**Umbila Emoyeni (Pty) Ltd**  
15 Chaplin Street  
Illovo  
2196

**RE: UMBILA EMOYENI WIND ENERGY FACILITY AND ELECTRICAL GRID INFRASTRUCTURE PHASE ONE: RESPONSE TO ECOLOGICAL WALKTHROUGH RECOMMENDATIONS (DFFE REF: 14/12/16/3/3/2/2160 & 14/12/16/3/3/2/2162)**

*Table 1 Ecologist's recommendations and Applicant Responses (refer to Figure 1)*

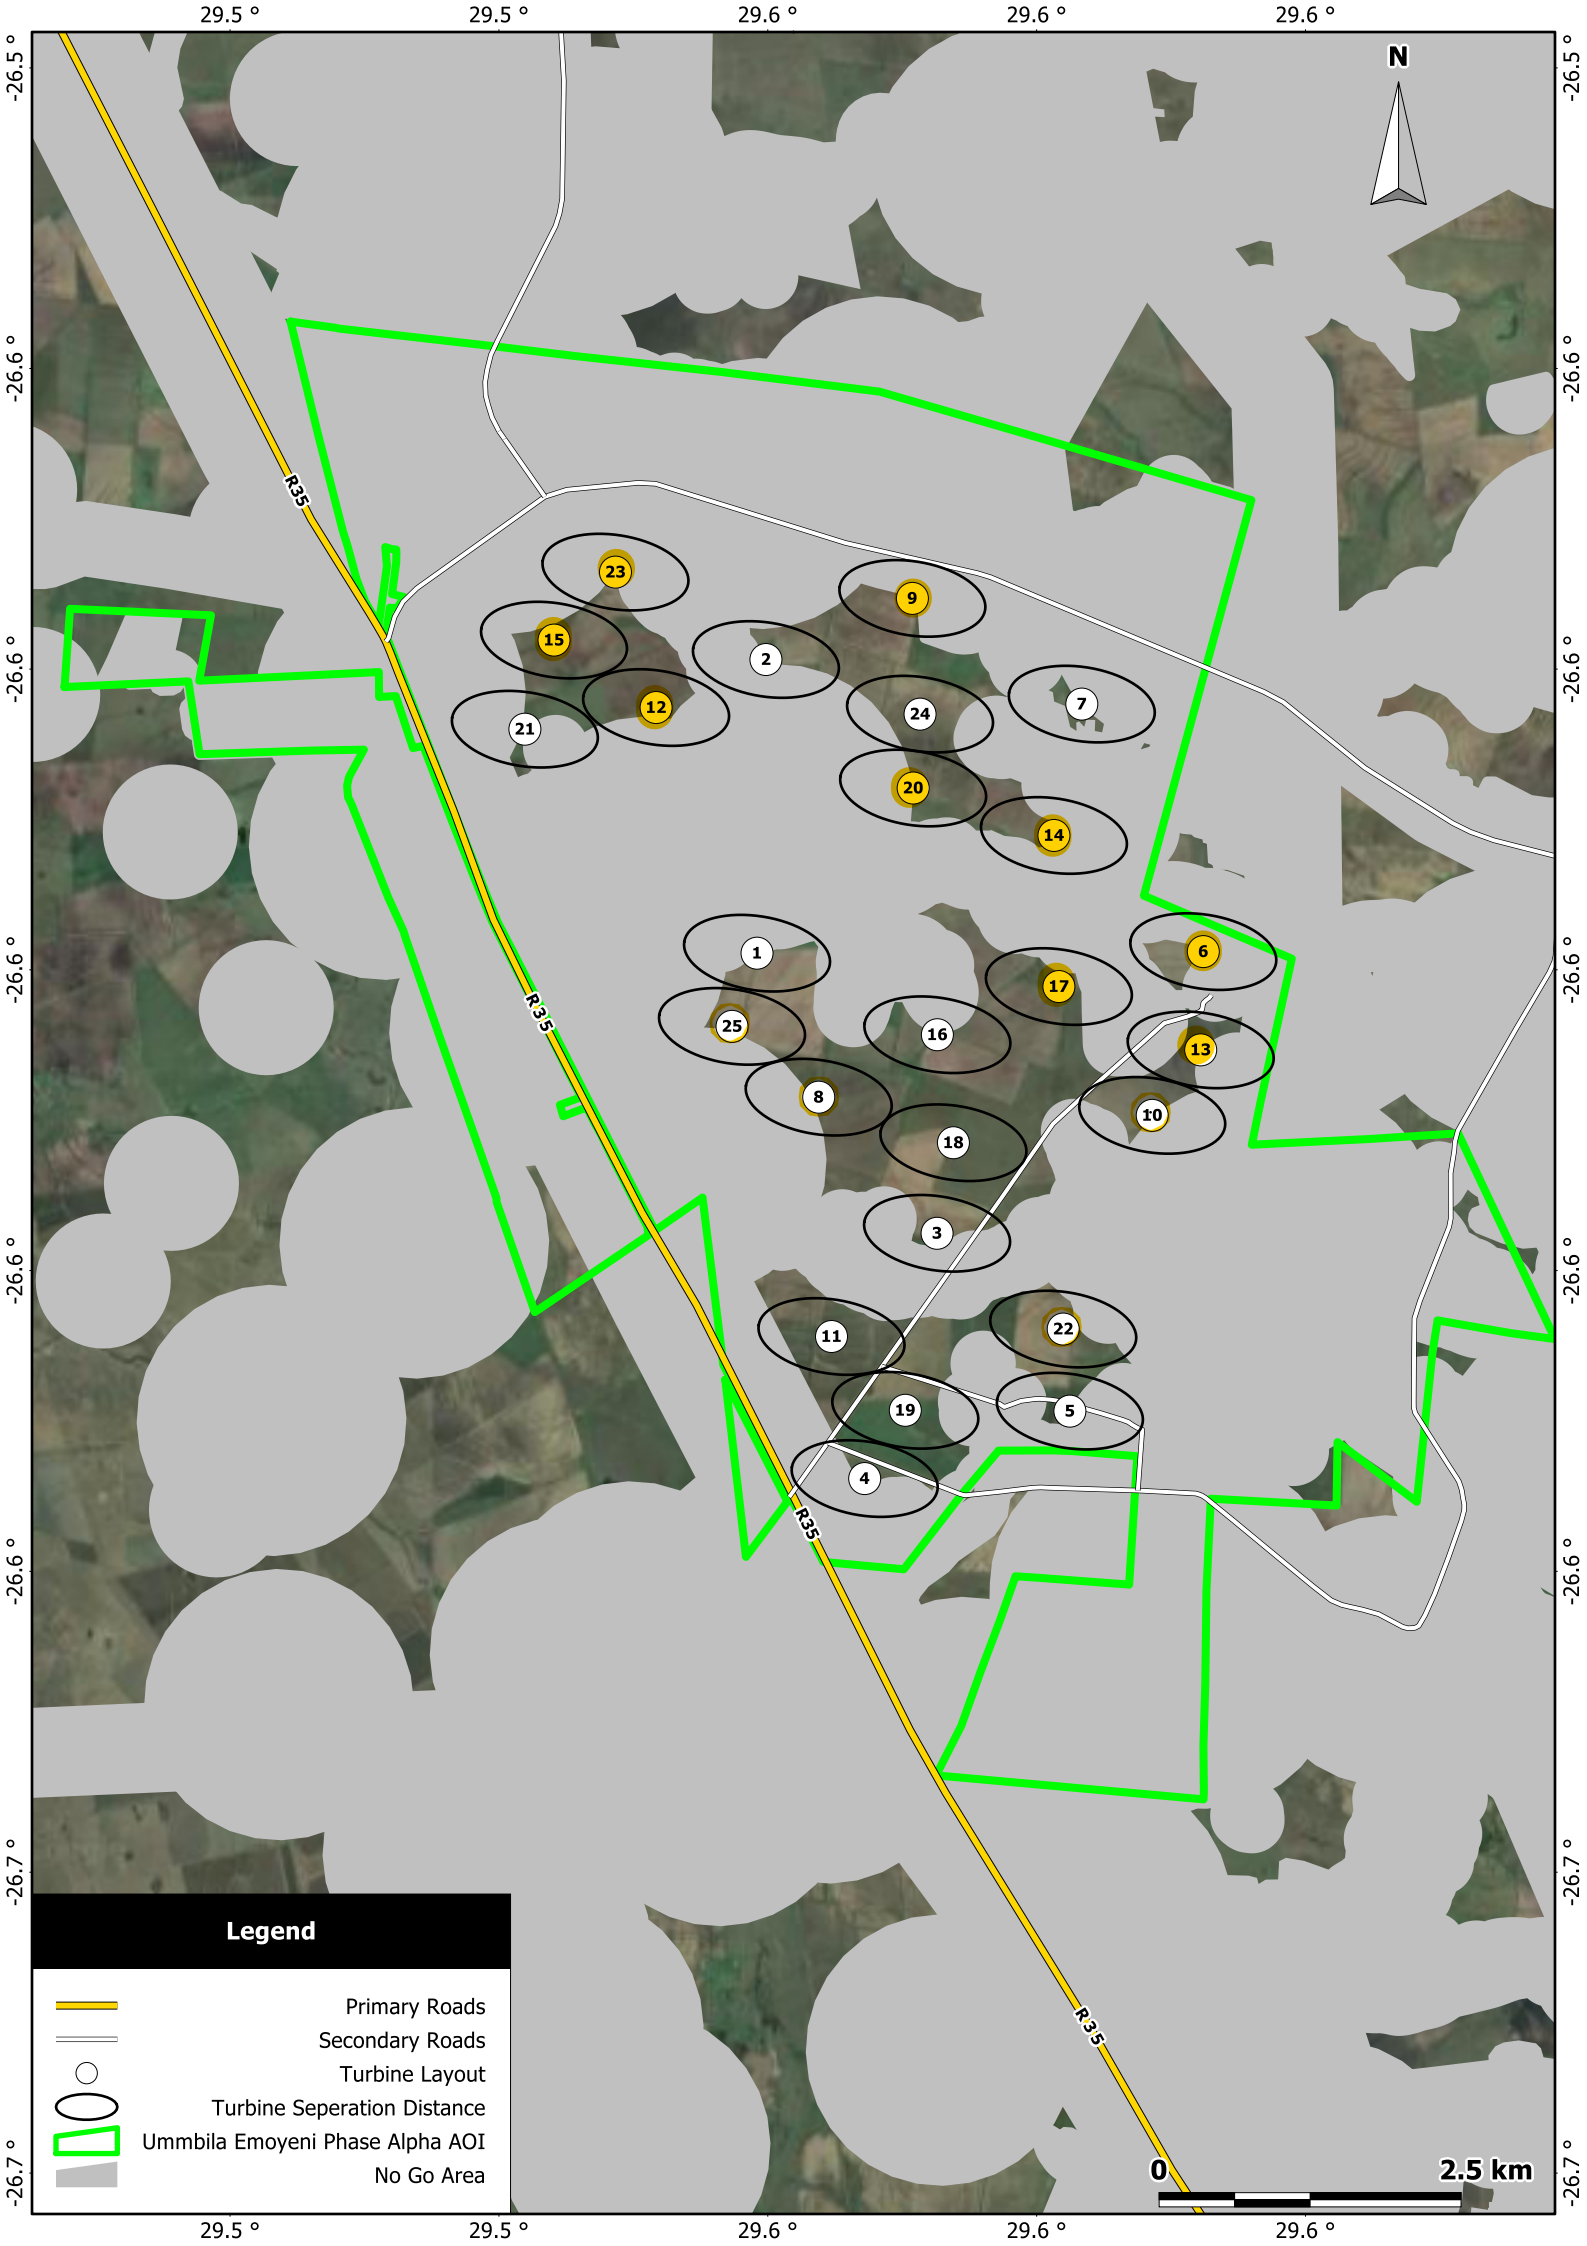
The site for Phase One is highly constrained, with “no-go” areas identified based on ecological and social constraints during the WEF and EGI EIA processes (Figure 1, grey areas). In addition to the ecological and social constraints, is the need for the WTGs to be separated from each other for safety and to avoid turbulence resulting from wake effect. The turbine supplier is required to produce a site suitability report that requires a set distance between each turbine - this is shown in Figure 1. Turbines cannot infringe on this separation distance without compromising the ability of the turbine supplier to provide an availability guarantee. This is a guarantee that the WTG will perform to a minimum specified standard. This means that the WTGs making up the wind farm must be spaced out, with distance increasing with increasing rotor diameter, and a greater distance for main wind direction than cross wind directions. The rule applied to Umbila Emoyeni (91m blade length) is a minimum spacing between the individual WTGs of three rotor diameters in cross wind directions and six rotor diameters in main wind direction. Figure 1 shows that there is near to zero space available to move turbines.

To ensure that we are taking appropriate steps, the ecologists have suggested a repositioning of 12 WTGs, with recommendations ranging from 30m to 700m shifts in location and, in some cases, adjustments to allow for easier access. While none of the requests are based on significant or fatally flawed environmental concerns, it may not be feasible to implement any of the recommended changes due to the highly constrained site and required separation zone between the WTGs. However, the appointed contractor will investigate the possibility of making slight position adjustments once on site. It should be noted that these adjustments are unlikely to match the degree recommended by the ecologists. A summary of the Ecologists’ recommendations and the Applicant’s responses can be found in the attached table.

<b>Infrastructure</b>	<b>Recommendation</b>	<b>Response</b>
<b>T1</b>	Position remains unchanged.	N/A
<b>T2</b>	Position remains unchanged.	N/A
<b>T3</b>	Position remains unchanged.	N/A
<b>T4</b>	Position remains unchanged.	N/A
<b>T5</b>	Position remains unchanged.	N/A
<b>T6</b>	Keep Turbine on the road next to the fence line.	The WTG cannot be shifted east as it would encroach on the "no-go" area.
<b>T7</b>	No changes to placement area required.	N/A
<b>T8</b>	Move Turbine to the nearest road east of Soya lands.	The WTG cannot be shifted east as it would impact on the separation zones of WTGs 16 and 18.
<b>T9</b>	Move Turbine slightly east into the road next to the natural veld. Access will be easier.	WTG 9 is on the edge of the "no-go" area and therefore cannot be moved east.
<b>T10</b>	Move Turbine to the nearest road crossing south-east of Soya lands.	WTG 10 is on the edge of the "no-go" area and therefore cannot be moved south-east.

<b>T11</b>	Position remains unchanged.	N/A
<b>T12</b>	Move Turbine slightly west into the road crossing. Access will be easier.	The WTG cannot be shifted west as it would impact on the separation zones of WTGs 15 and 21.
<b>T13</b>	Move Turbine towards the nearest road east of Soya lands. Do not place the Turbine on the other side of the road.	WTG 13 is on the edge of the "no-go" area and therefore cannot be moved east.
<b>T14</b>	Move Turbine south to the nearest road crossing next to mielie lands. It will be easier to access the turbine.	WTG 14 is on the edge of the "no-go" area and therefore cannot be moved south.
<b>T15</b>	Move Turbine position north onto the road crossing, for easier access.	WTG 15 is close to the edge of the "no-go" area as well as the zone of separation of WTG 23 and therefore cannot be moved north.
<b>T16</b>	Position remains unchanged.	N/A
<b>T17</b>	Move Turbine south to the nearest road crossing next to mielie lands.	The WTG cannot be shifted south to the nearest road crossing as it would impact on the separation zones of WTGs 13 and 16.

<b>T18</b>	No changes to placement area required. Relocation (rescue) of protected plants.	N/A in terms of relocation. Applicant is completing permit applications for the relocation of protected plant species.
<b>T19</b>	Position remains unchanged.	N/A
<b>T20</b>	Move Turbine slightly south into the old cultivated land next to the road, access will be easier.	The WTG cannot be shifted south as it would impact on the separation zone of WTG 14.

<b>Infrastructure</b>	<b>Recommendation</b>	<b>Response</b>
<b>T21</b>	Position remains unchanged.	N/A
<b>T22</b>	Position remains unchanged. The position of the collector site could also be moved 100 m south in case the nest recorded is active.	N/A in terms of relocation of the WTG. Applicant will monitor the nest for activity to determine the need for relocating the collector site.
<b>T23</b>	Move Turbines position slightly south onto nearest contour line of the maize fields.	The WTG cannot be shifted south as it would impact on the separation zone of WTG 15.
<b>T24</b>	Position remain unchanged.	N/A
<b>T25</b>	Move Turbine slightly east to the road or south to the road crossing. Access will be easier.	The WTG cannot be shifted east as it would impact on the separation zones of WTG 1 and 8. Moving the WTG south would place the turbine within the “no-go” area as well as impacting on the separation zone of WTG 8.
